November 5, 1993

SUBJECT: Response to FDEP Request for Information
Regarding: Operating Permit Application Renewal
Permit No. UO 56-237554
North Port St. Lucie Injection Well IW-1

On behalf of St. Lucie County Utility Services Department (SLCUSD), Montgomery Watson is pleased to submit three copies of the response to the Florida Department of Environmental Protection (FDEP) Request for Information (RFI) regarding Operating Permit Application for Injection Well IW-1 at the North Port St. Lucie Injection Well System, Permit No. UO 56-237554, dated October 8, 1993.

FIGURE 1.
GDU North Port WWTP and 1-Mile Radius Area of Review.

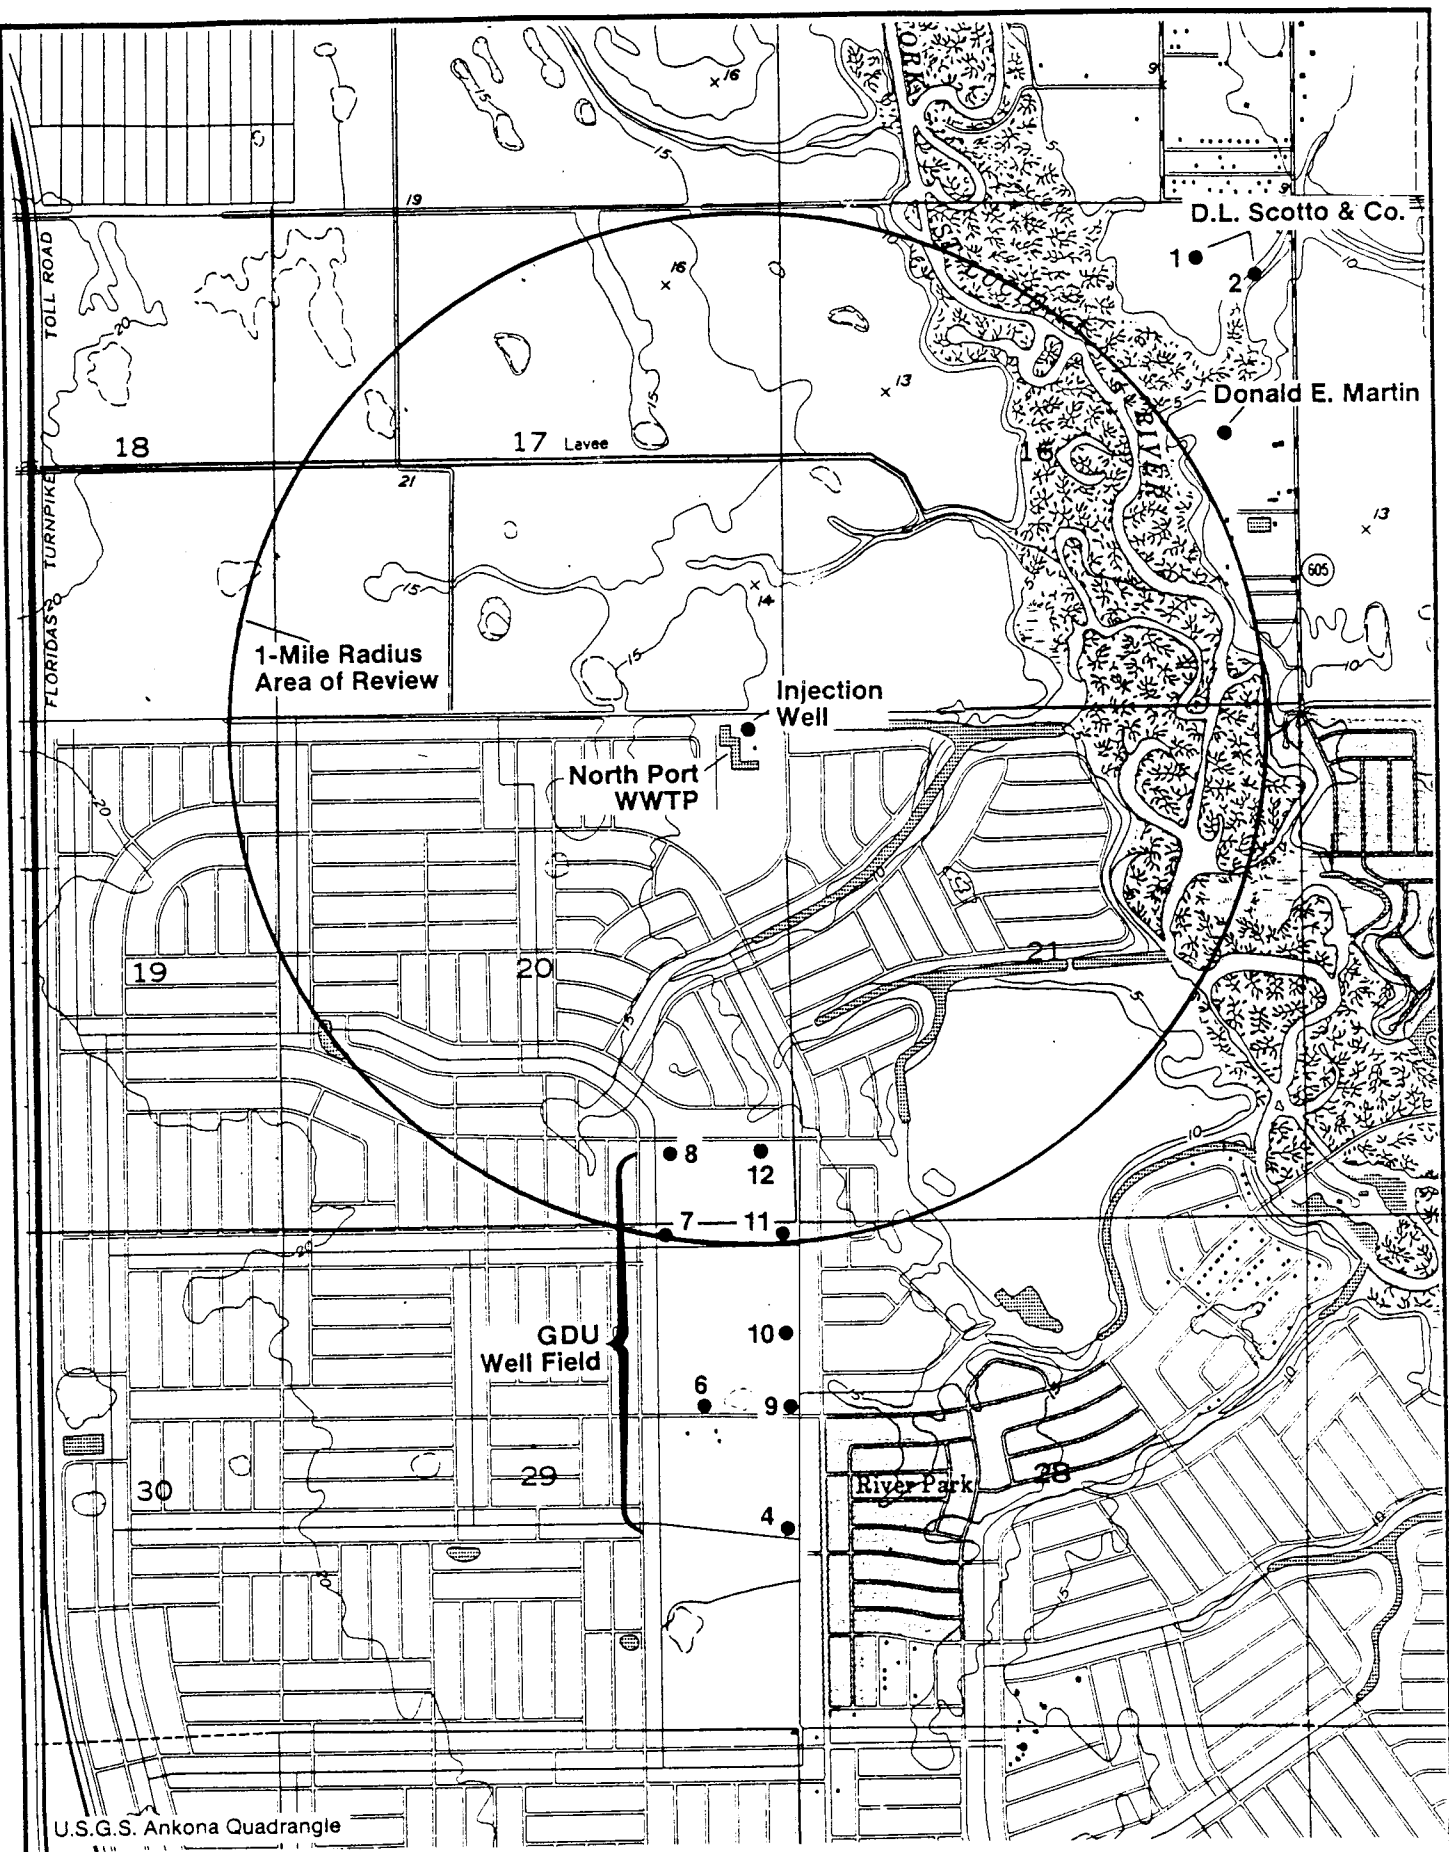
- 1. As required by Rules 17-28.130(4) and (5), and 17-28.340(1), F.A.C., a map showing the location of the injection well field and the applicable area of review is needed for this facility. Within the area of review, the map must show the number or name, location of all producing wells, injection wells, abandoned wells, dry holes, surface bodies of water, springs, public water systems, mines (surface and subsurface), quarries, water wells and other pertinent surface features including residences and roads. Any wells identified on this map should be listed on a table with owner, location and depth identified. The map should also show faults, if known or suspected. Only information of public record and pertinent information known to the applicant is required to be included on this map.**

Provided in Attachment A, Figure 1, excerpted from the initial Operating Permit Application for Injection Well IW-1 at the North Port St. Lucie Injection Well System

(NPSLIWS), Permit No. UO 56-237554, dated April 1988, shows the location of the injection wellfield and the applicable area of review. This map shows wells identified within the area of review which penetrate the injection zone, confining zone, and/or monitoring zones, and is accompanied by a table listing the well owners, locations, diameters, and permit numbers. Copies of South Florida Water Management District (SFWMD) Well Completion Reports on file for wells constructed in or near the area of review since 1985 have been included in Attachment B. The well completion reports do not provide a specific location for each well and, as a consequence, have not been located on a map or listed on a table. All of these wells are completed in the surficial aquifer.
